Re: Erkinger Construction / Bryan B & Robin L Smithey Res / Brown Road, Lake City FL

Please accept this letter as an addendum to the sealed engineering for the above referenced project.

ATTACHMENT OF NON-STRUCTURAL BEAM TO TRUSS

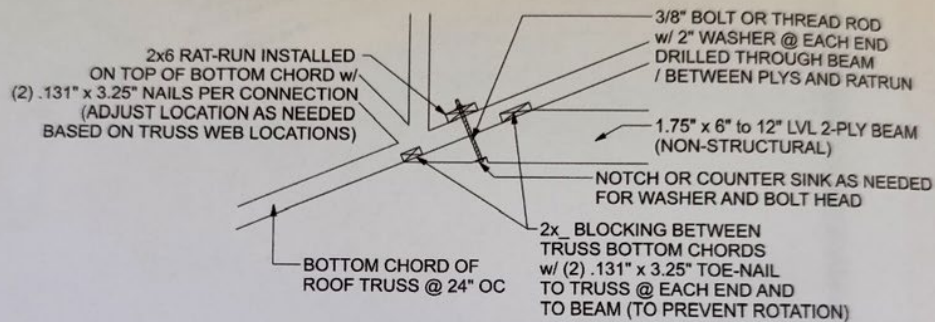
- This plan calls for non-structural beams below the vaulted trusses in the family room.
Attachment detail for beams to truss system below:
